Consultation on economic asset valuation for the bioresources RCV allocation at PR19

Severn Trent response

Neil Corrigan
31 March 2017

Figure 1: RCV impact on efficient Company A

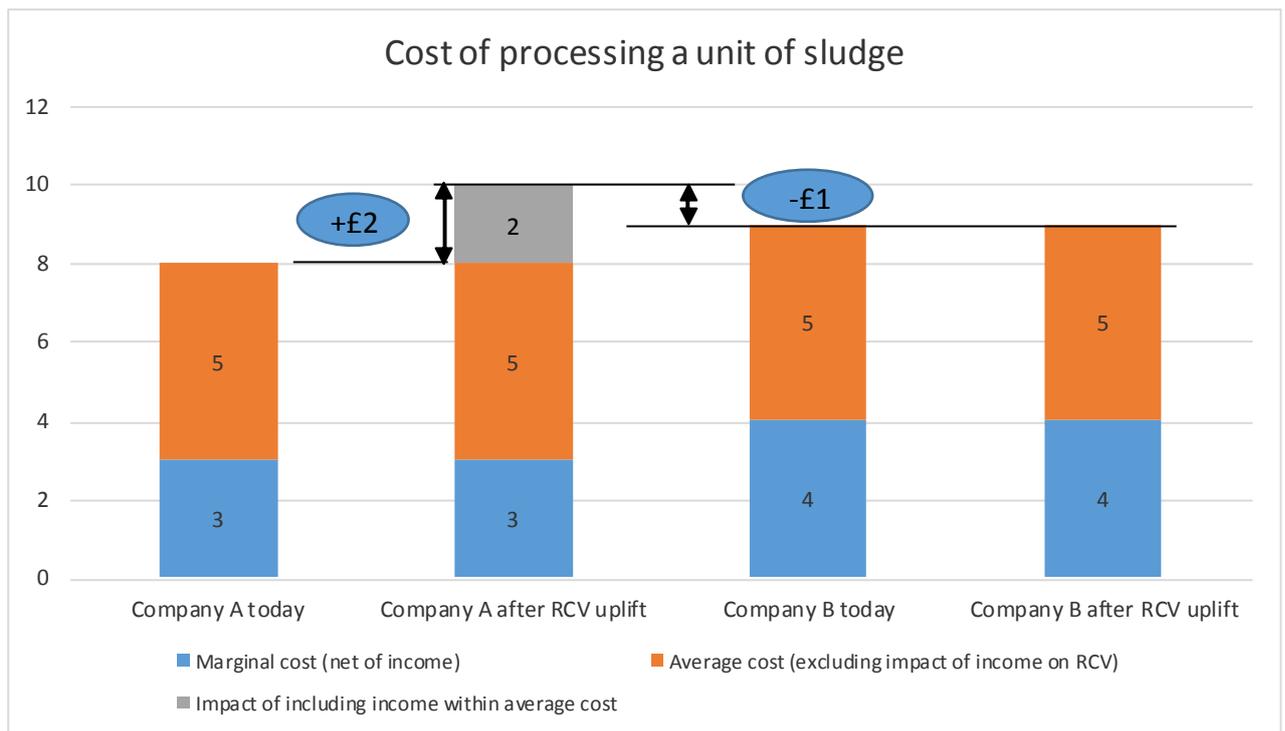
The impact of the RCV increase is illustrated above – it turns an efficient company A, which currently has the lowest net treatment costs, into the one that has the highest average price (based on fully allocated costs) after capitalised income has been added to the RCV. The steps are as follows: today Company A can process sludge cheaper than company B (£8/unit vs. £9/unit). The addition of income into the RCV impacts company A negatively such that the average price for committed capacity contracts (including a return on RCV) rises from £8 to £10. Company B is now able to tender into the market £1 cheaper than company A despite being less efficient. This ends in average prices being raised in the market and an inefficient outcome.

Retain the existing methodology but limit the RCV to a reflection of costs. Accordingly we propose Ofwat should exclude from the valuation any income which is a product of previous management policy and not asset capability – i.e. exclude Tanker trade waste income, sludge to land income and ROC income.

Figure 2 – Impact on long term capacity trades

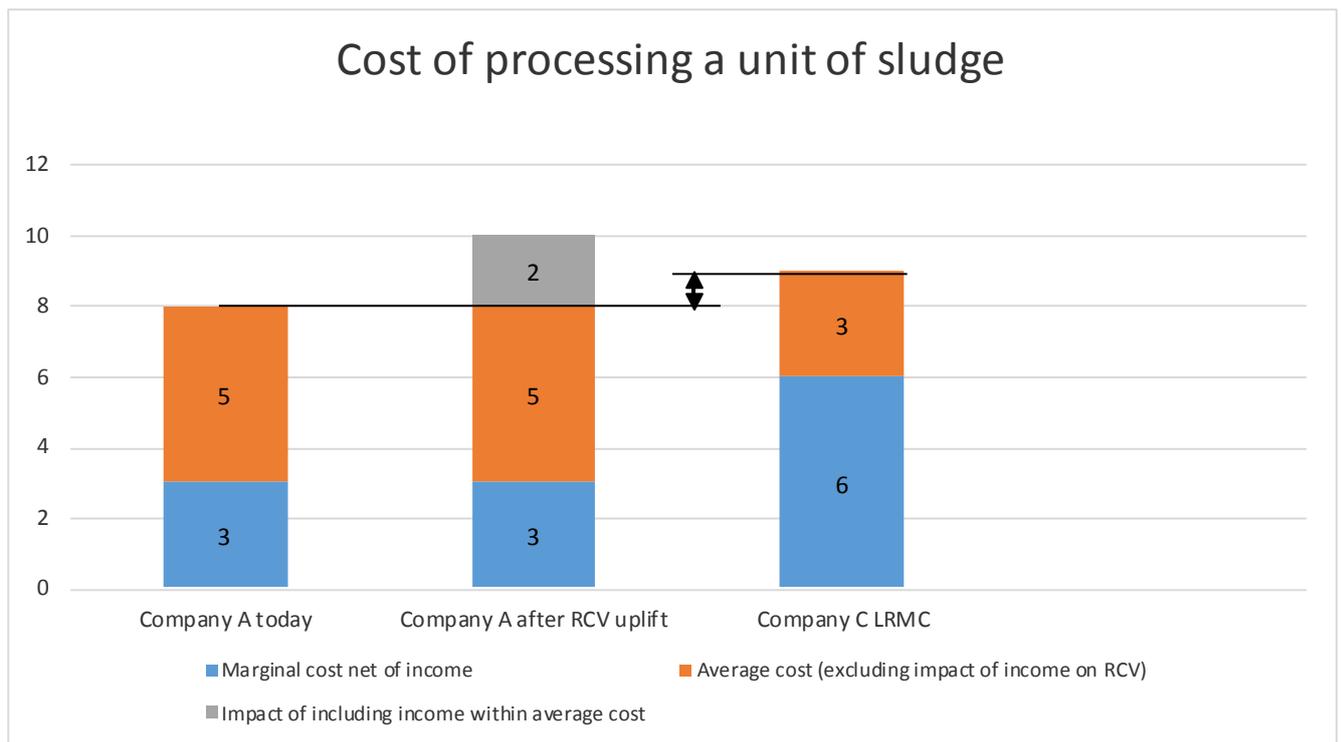
- ii) Addition of income into RCV could increase the average cost an efficient company has to charge for committed contracts, meaning that trade may be suppressed. The issue is shown in figure 2.

In the example above Company A has marginal processing costs (net of income) of £3/unit, additional allocated fixed costs of £5/unit. Company C has long run marginal costs (LRMC) of £9/unit (and no income).

Long term trades (where payments for committed capacity are required) would be possible because the average cost of Company A is below the LRMC of Company C. This difference incentivises both parties to enter a firm capacity trade with the likely impact of reduced costs for customers of Company C and the avoidance of unnecessary capacity being built.

After income is added into RCV, Company A's average costs are artificially increased to £10. The inefficient Company C now has a LRMC lower than the efficient company's average cost and so will choose not to trade (under a long term contract where payments for committed capacity are required). Company C is now incentivised to build new, unnecessary capacity rather than trade.

Figure 3: distortion to encourage inefficient new entry

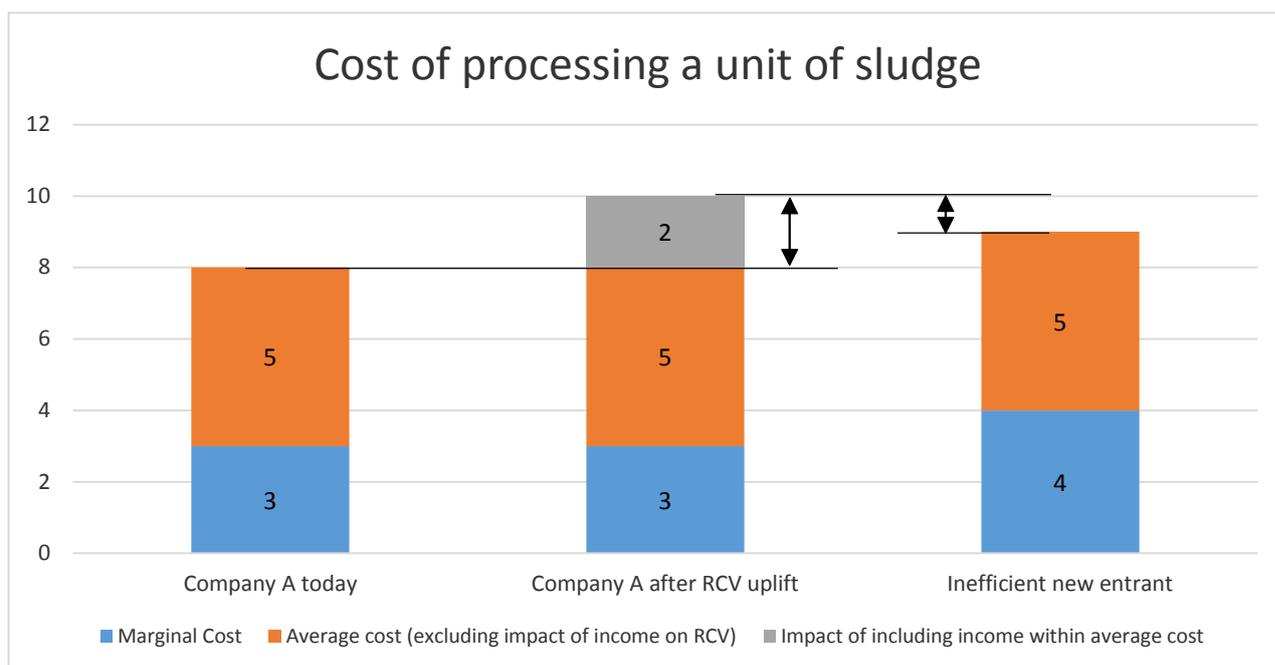
- iii) New entrants to the market may have an Average Cost lower than the artificially inflated WaSC Average Cost, but higher than the true Average Cost. On this basis the new entrant would be incentivised to inefficiently enter the market, resulting in higher overall costs to the system as shown in Figure 3.

In this example, the new entrant has a less efficient cost structure than Company A. The new entrant will choose to inefficiently enter as Company A would need to recover its full cost including the uplifted RCV and this increases the overall costs of the system.
